INVITATION FOR BIDS

CCK-2568-22
ADDENDUM # 3
09/02/2021

2555.0 Construct/Improve Greek Housing

Addendum #3

FOUNDATION/BASEMENT DEMO PLAN

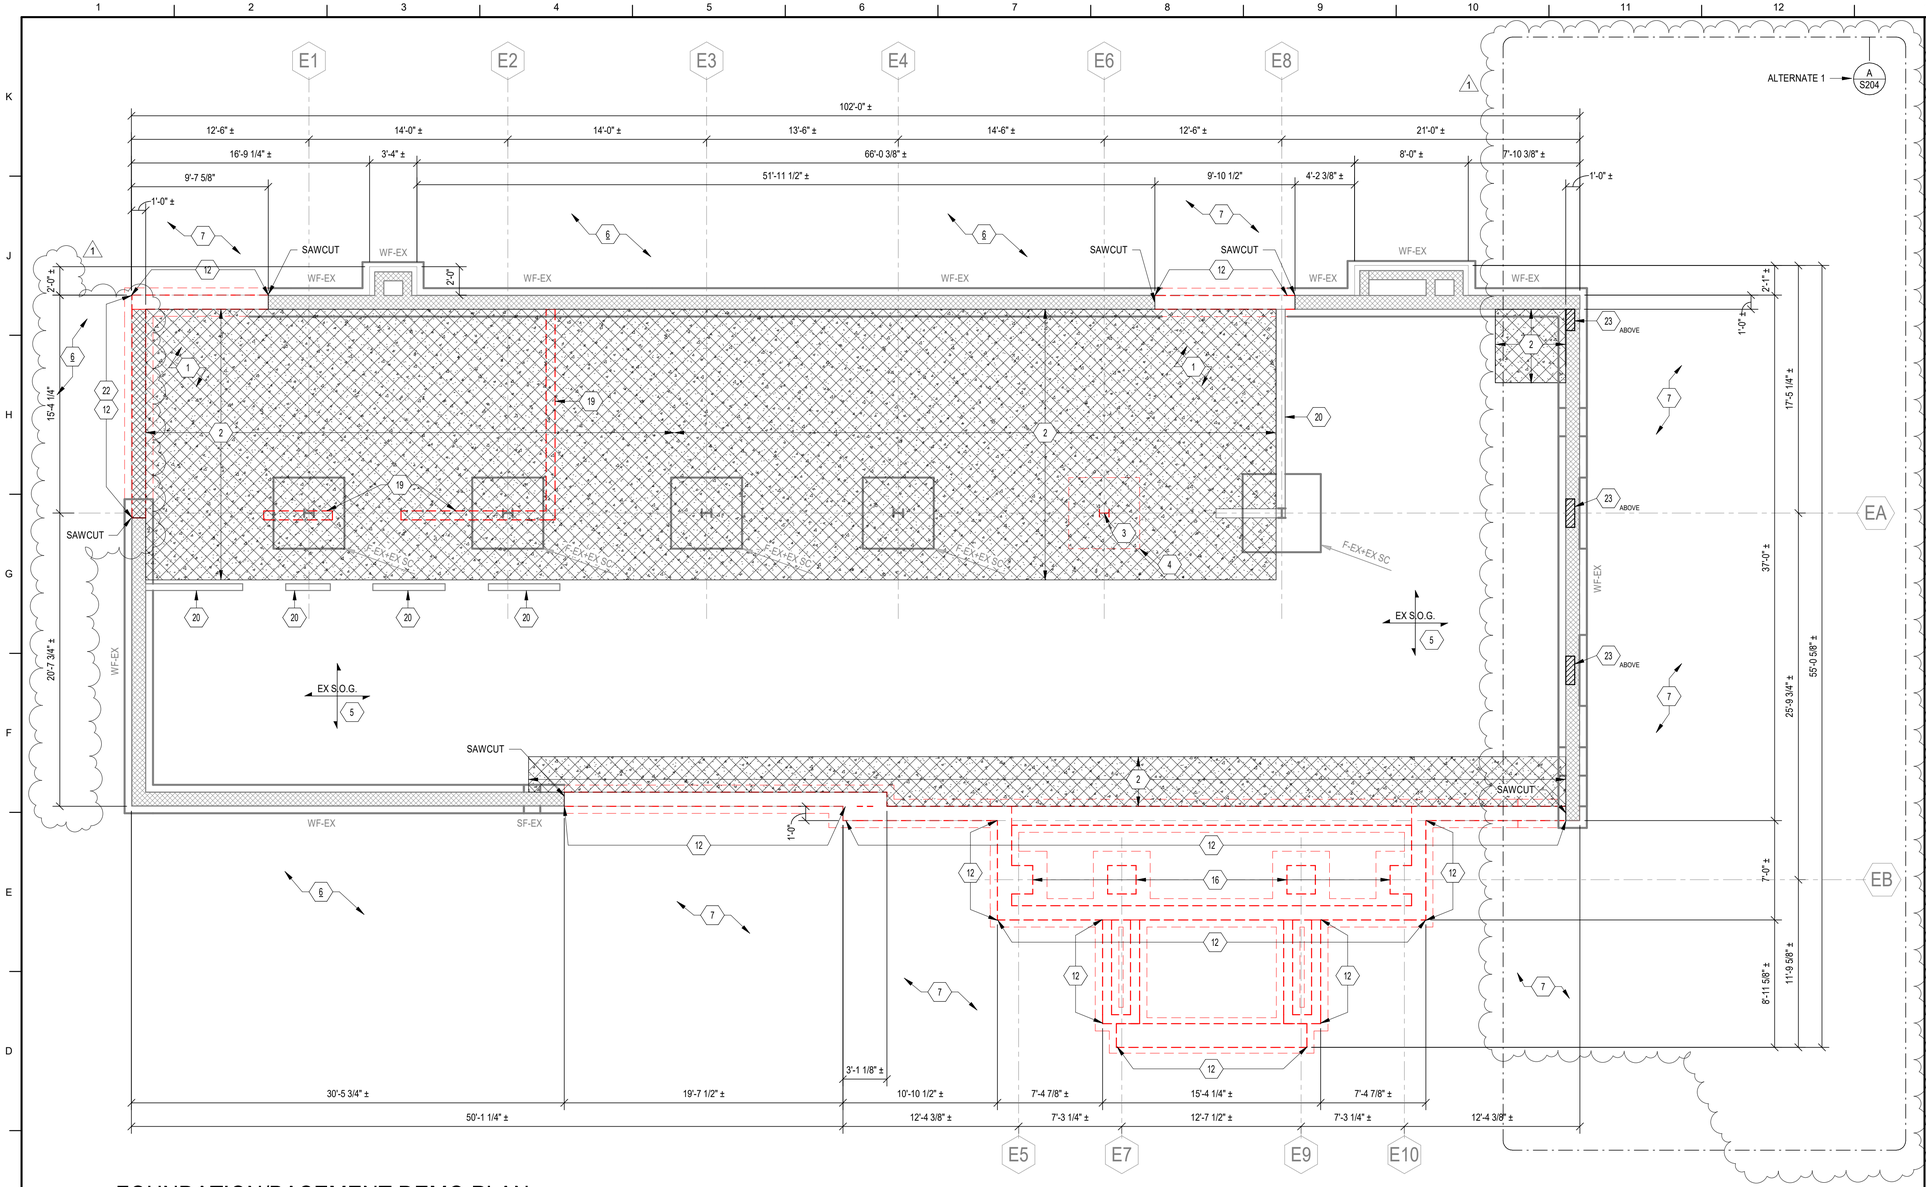
SD200	FOUNDATION/BASEMENT DEMO PLAN	9/1/21

- Updated plan for option to keep existing plan west stair wall.
- Updated plan to reflect new base bid structure.
- Added tag notes 22 and 23.

SECOND FLOOR DEMO PLAN

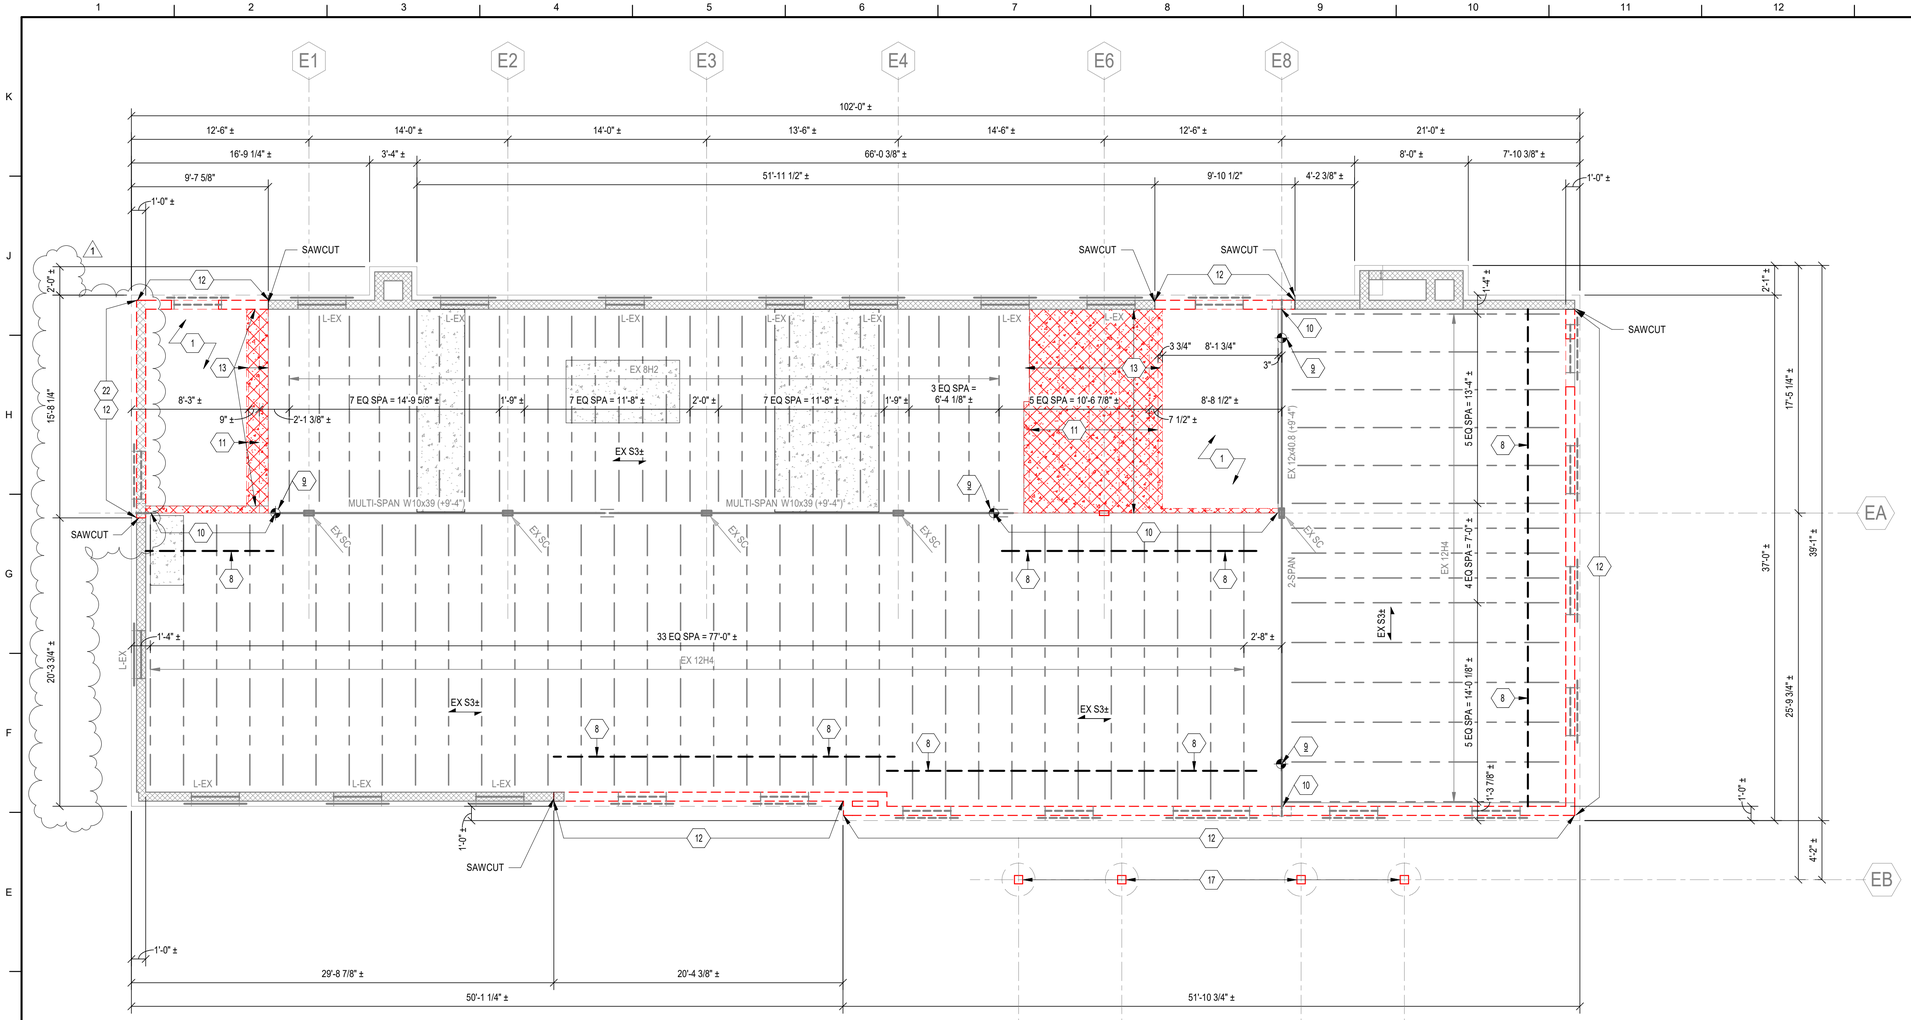
SD202	SECOND FLOOR DEMO PLAN	9/1/21

- Updated plan for option to keep plan west south wall.
- Added tag notes 22 and 23.

A S200 FOUNDATION/BASEMENT PLAN

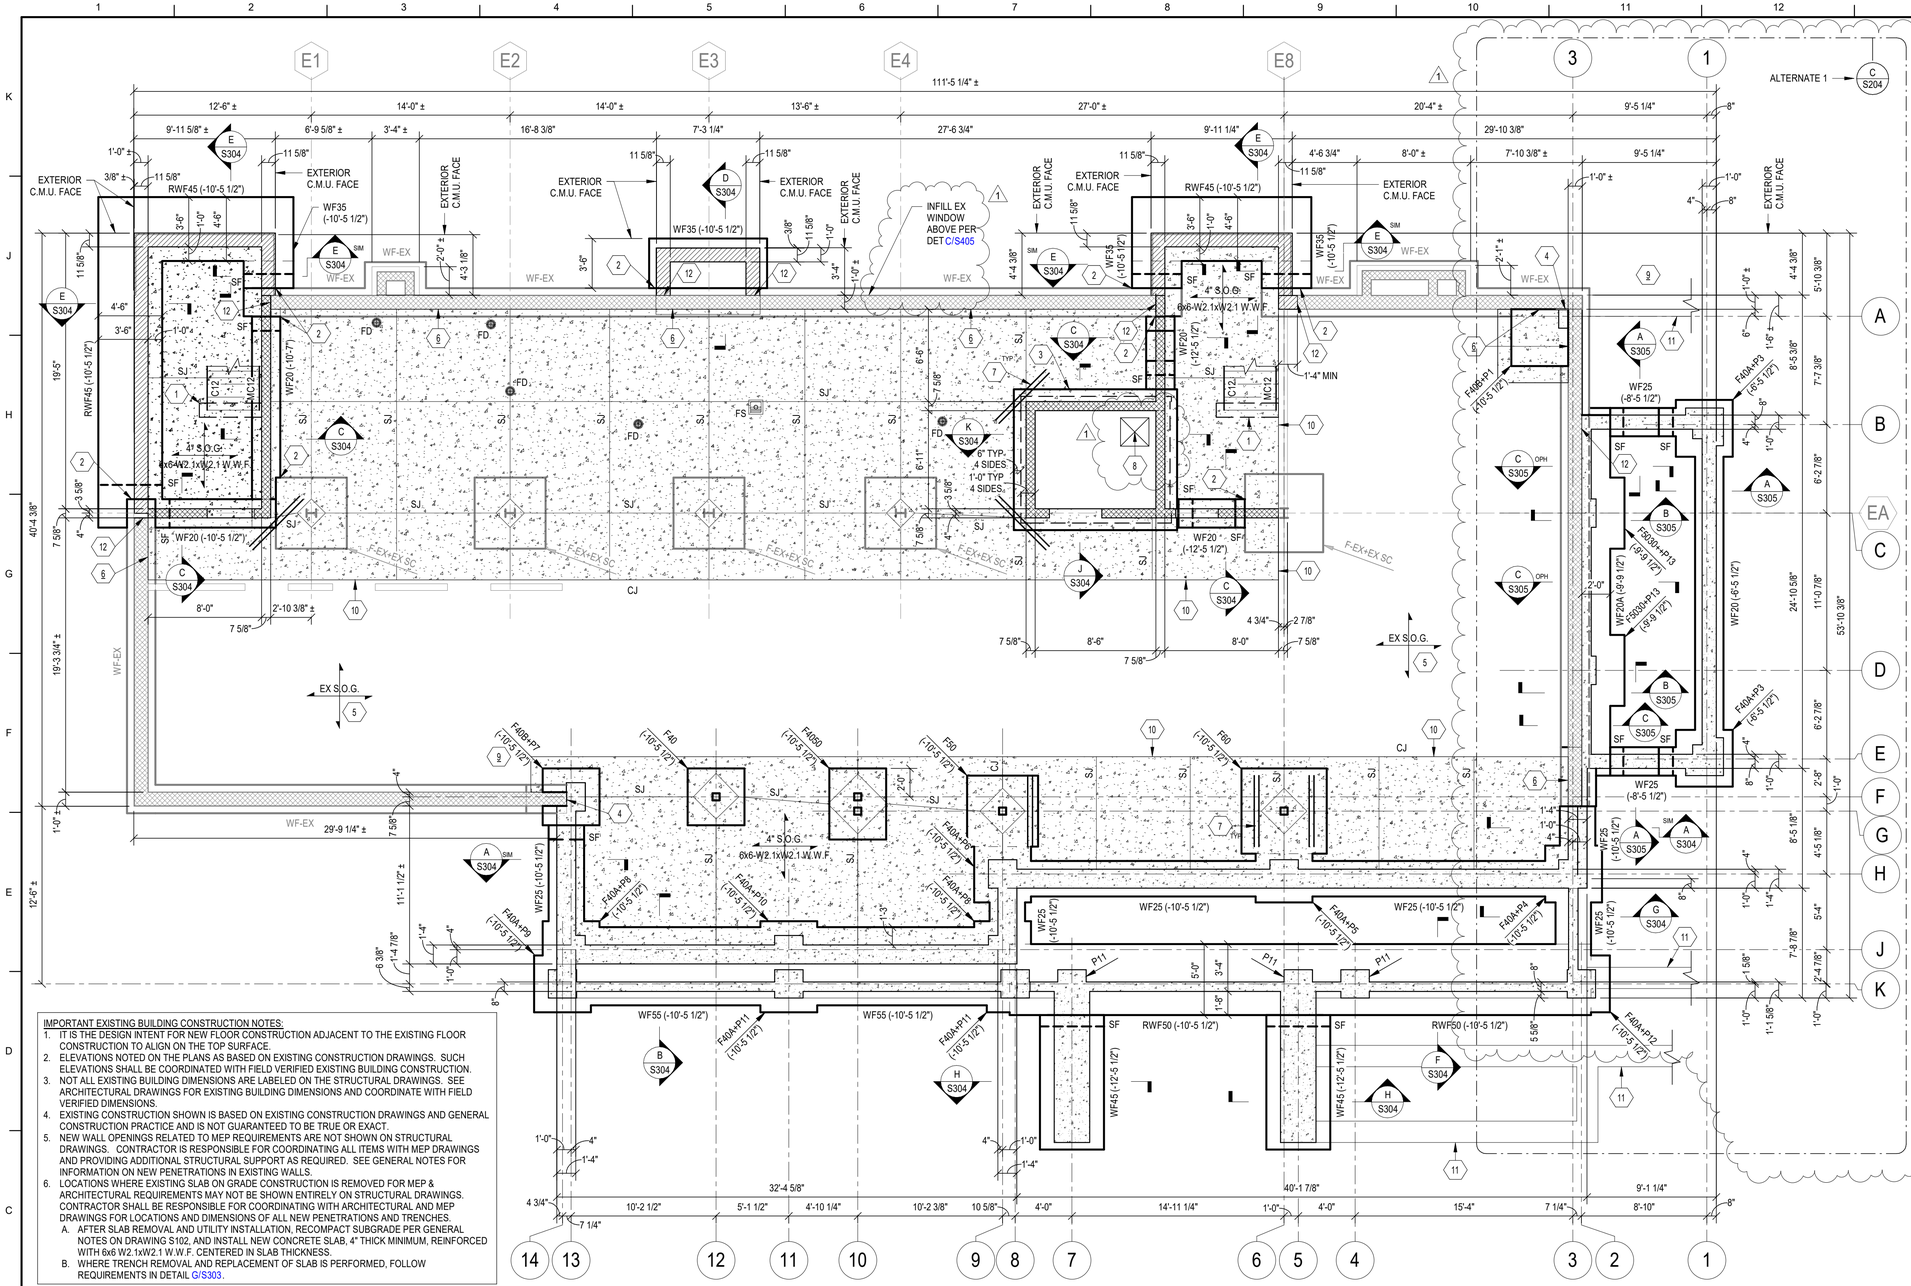
S200	FOUNDATION/BASEMENT PLAN	9/1/21

- Added notes for existing window infill.
- Updated plan and reference sections to reflect new base bid structure.
- Corrected sump pump location at elevator pit.
- Added W20A and F5030 to foundation schedules.

F1 WEST DEMO ELEVATION

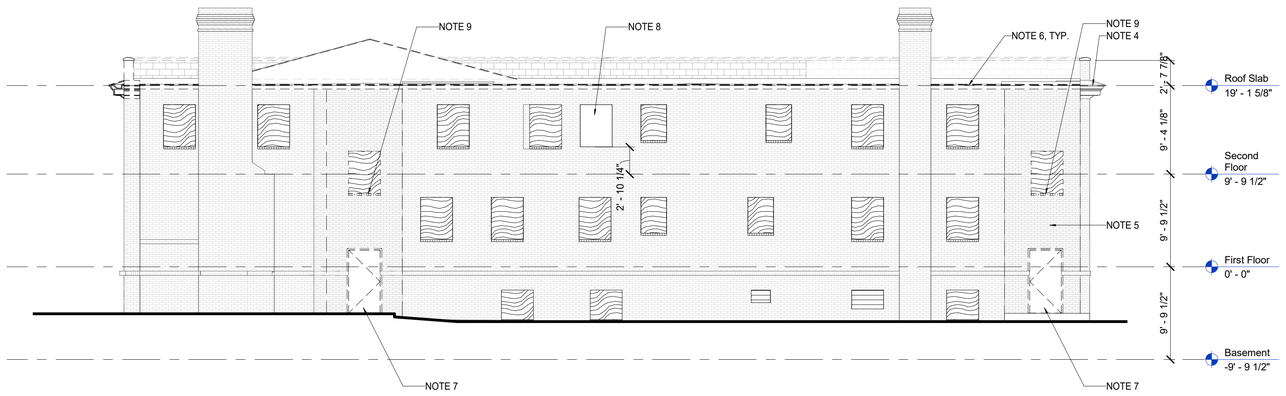
- Adjusted Basement elevation to show the basement wall remaining in view F1. The Level 01 and level 02 walls above are to be demolished. The basement wall windows are to be removed still.

D6 ENLARGED RCP - LIVING ROOM / FOYER

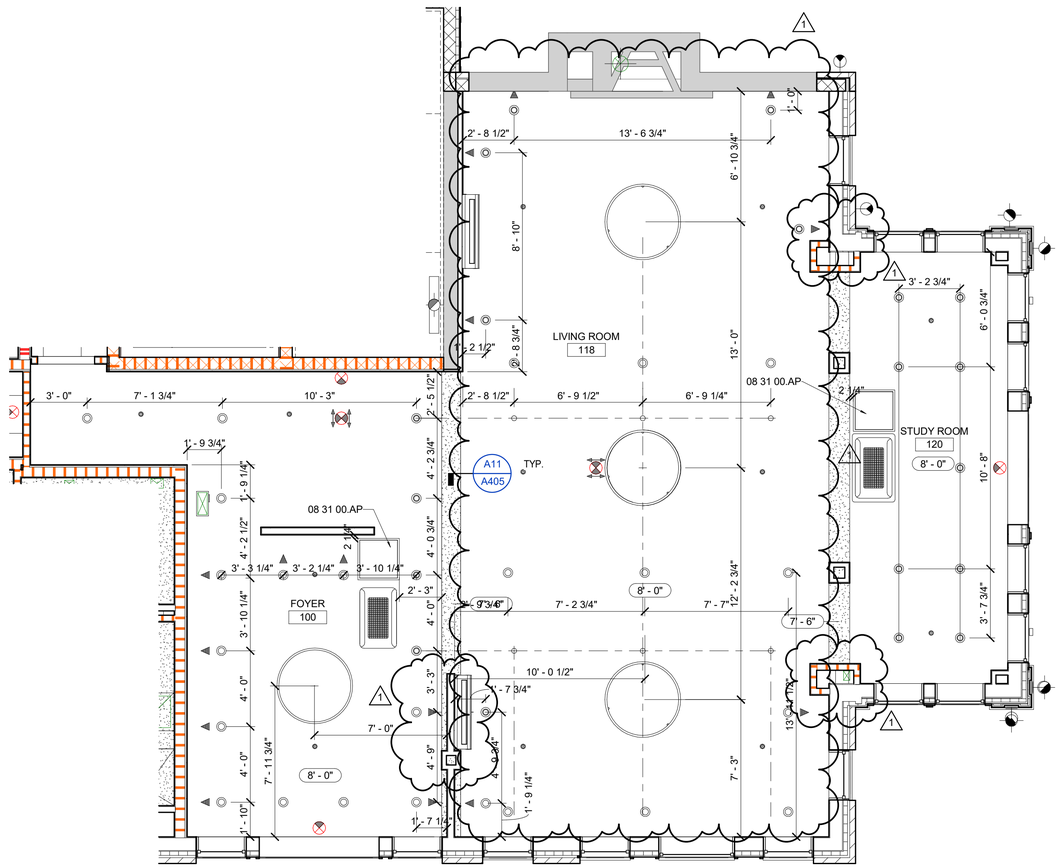
- Living Room Ceiling Fixtures adjusted per Interior Designer comments.
- Ring fixture added and all fixtures better centered in space.
- Pendants removed.
- Chase walls were adjusted between Living Room 118 and the Study Room 120.
- Wall Mounted Air Unit plan east was relocated towards Foyer due to chase wall changes.
